Access Compliance Report

Public Rights-of-Way

(Curb Ramps)

Intersection ID: 28287	Main Street: BRANDON_BROOK_DR	Cross Street: OLD_ARDREY_KELL_RD	Location: SE
ADA ID: 7ABACEE52820	Ramp Type: Perp	Initial Pass/Fail: Fail	Overall Compliance: No
Severity Score: 37.5			
Codes/Mitigation Info/Possible Solution		Field Measurements/Component Compliance

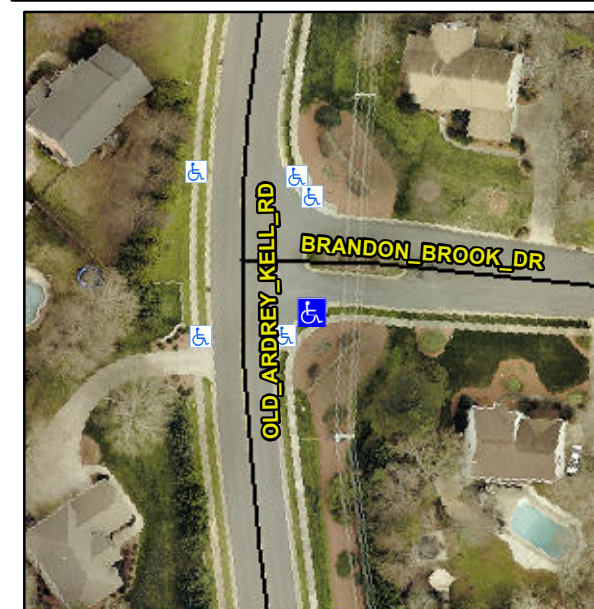
Not Found, R304.2.2, R304.5.3

Compliance	Description	Data	Compliance	Description	Data
N/A	Ramp Length (in)	95.0	No	Ramp Slope (%)	9.1
Yes	Ramp Width (in)	48.0	No	Ramp XSlope (%)	11.3
N/A	Flare Type LT	N/A	N/A	Flare Type RT	N/A
N/A	Flare Slope LT (%)	N/A	N/A	Flare Slope RT (%)	N/A
N/A	Flare Traversable LT?	N/A	N/A	Flare Traversable RT?	N/A
N/A	Landing Length (in)	N/A	N/A	DWS Provided?	N/A
N/A	Landing Width (in)	N/A	N/A	DWS Contrast?	N/A
N/A	Landing Slope (%)	N/A	N/A	DWS Length (in)	N/A
N/A	Landing X Slope (%)	N/A	N/A	DWS Full Width?	N/A
N/A	Landing Curb? (Y/N)	N/A	N/A	DWS Offset (in)	N/A
N/A	Shared Landing?	N/A			
N/A	Gutter Ponding?	N/A	N/A	Gutter Slope (%)	N/A
N/A	Gutter Lip Ht (in)	N/A	N/A	Gutter X Slope (%)	N/A
N/A	Painted X Walk1?	No	N/A	Painted X Walk2?	N/A
	X Walk 1 Direction	To NW		X Walk 2 Direction	N/A
N/A	X Walk 1 Width (in)	N/A	N/A	X Walk 2 Width (in)	N/A
	X Walk 1 Slope (%)	4.1		X Walk 2 Slope (%)	N/A
	X Walk 1 X Slope (%)	7.3		X Walk 2 X Slope (%)	N/A

Remove & Replace Entire Ramp.
